CERTIFICATE OF APPROPRIATENESS

Property: 642 Heights Boulevard, Lot 23, Block 277, Houston Heights Subdivision. The property includes a historic 1,235 square foot one-story brick veneered residence situated on a 7,500 square foot (50'x150') interior lot.

Proposal: Alteration – Revision. The applicant has exceeded the approved scope of work by removing the existing brick veneer, a portion of the original roof and reframing it at an increased height, a pair of windows, and the non-original front door. All existing materials were to remain, as stipulated in the previously approved COAs. The applicant now proposes to take the following remediate measures:

WEST ELEVATION – FRONT FACING HEIGHTS BOULEVARD

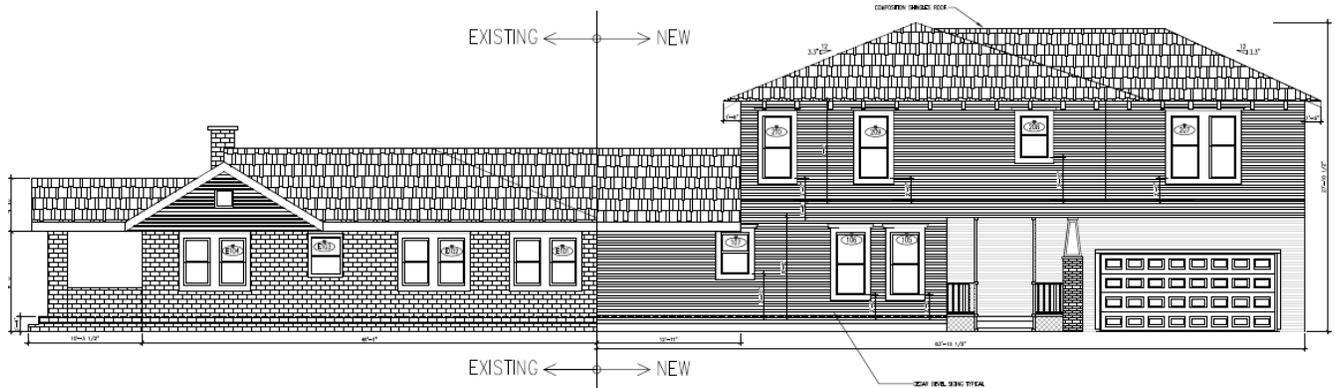
- Reinstall the original pair of windows
- Reinstall the original brick veneer to be supplemented with antique brick to match existing
- Reconstruct original roof to original configuration

Windows/Doors: The original residence featured 1-over-1 double hung wood windows. All of these windows were to remain. A pair of front windows were removed from the front façade and will be reinstalled.

SOUTH SIDE ELEVATION

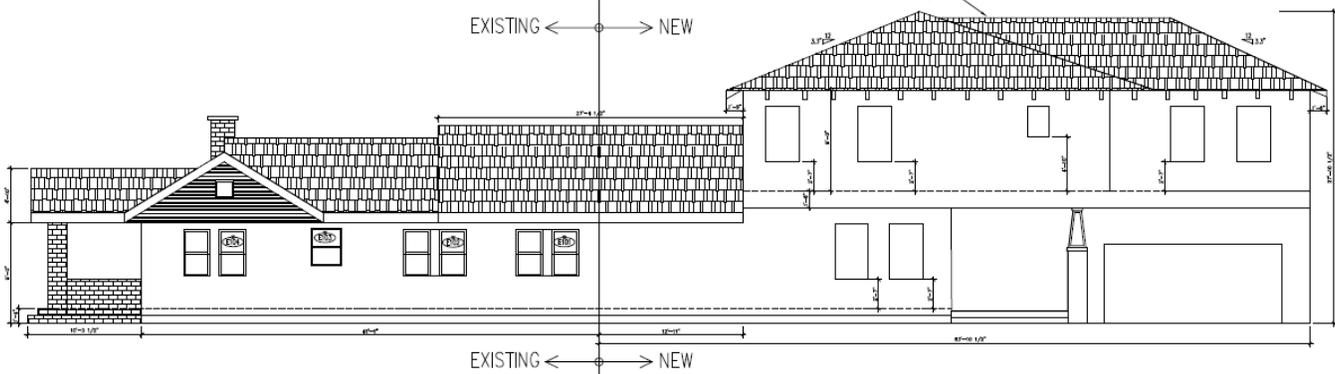
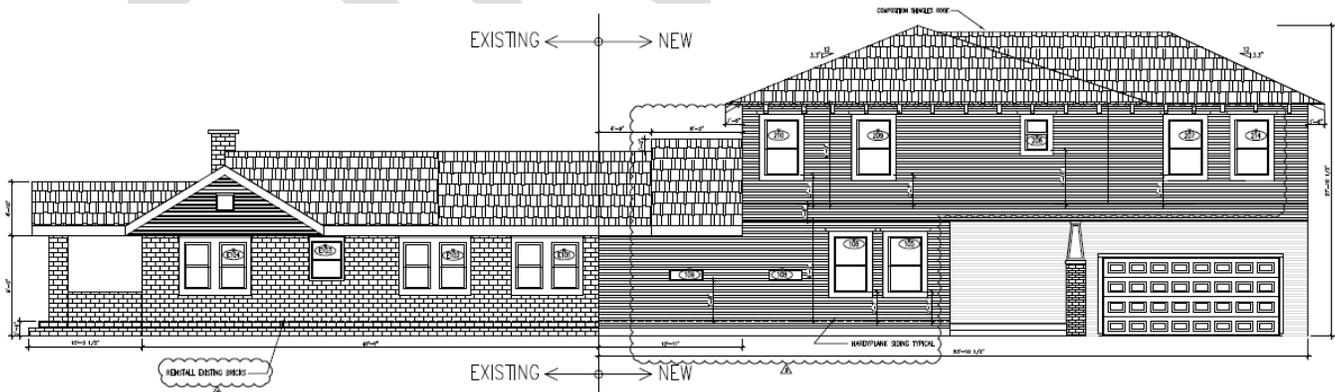
Roof: As part of the approved COA for the addition, the existing roof of the original structure was to remain. However, during construction, a portion of the original roof was removed and reconstructed at an increased height of 1'-2". The new unapproved roof encroached 18'-2½" into the original structure on the north elevation and 14'-5½" on the south elevation.

The current roof, not built to plan, will be removed and replaced with a roof that matches the original height and configuration. The raised roof of the addition will now begin 1'-0" behind the original rear wall of the house on the north elevation and 4'-9" behind the original rear wall on the south. See drawings for more detail.

DEMOLITION PLAN

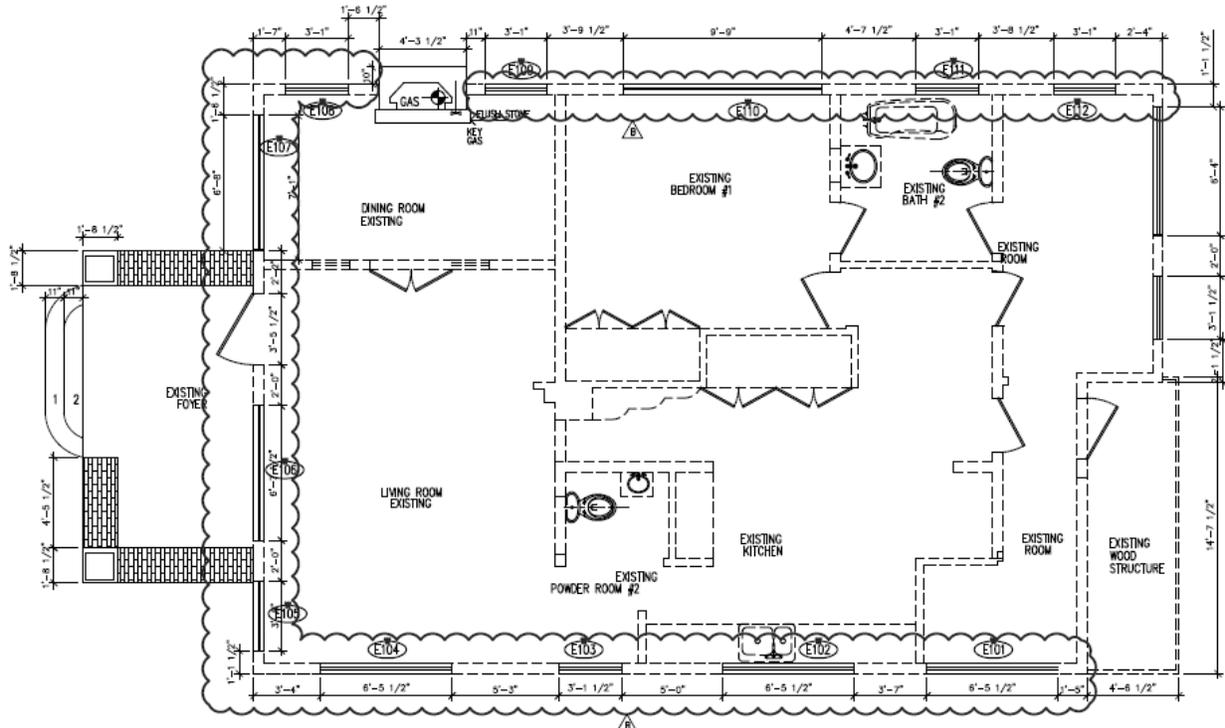
SHOWING WHERE BRICK WAS REMOVED

Exterior Materials: The existing residence was clad in painted brick veneer. During construction the original brick veneer was removed. Only the original porch and chimney remain.

Much of the original brick remains on site and the applicant proposes to reinstall the brick which will be supplemented with antique brick to match existing. The addition will now be clad in cementitious siding and not beveled lap siding as previously approved. The original shiplap was removed and the house was reframed. See photos and drawings for more detail.

PROPOSED DOOR DETAILS

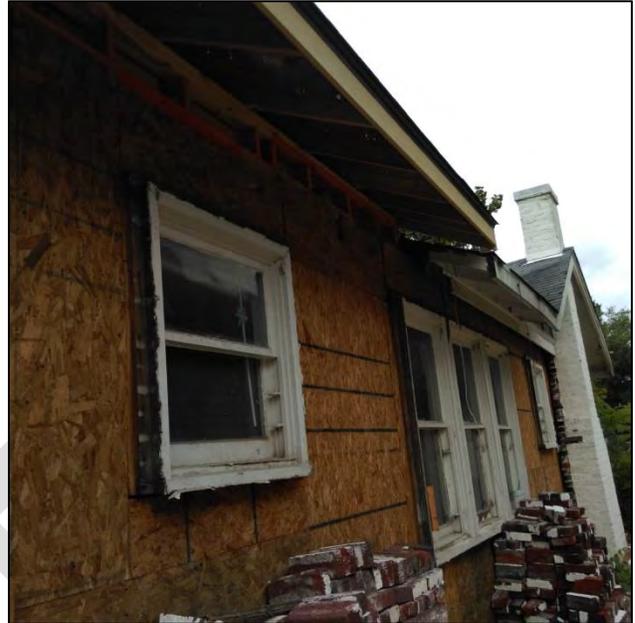
Several new windows are being added and altered in the addition. The non-original front door is also to be replaced. See drawings, window/door schedule, and photos for more detail.
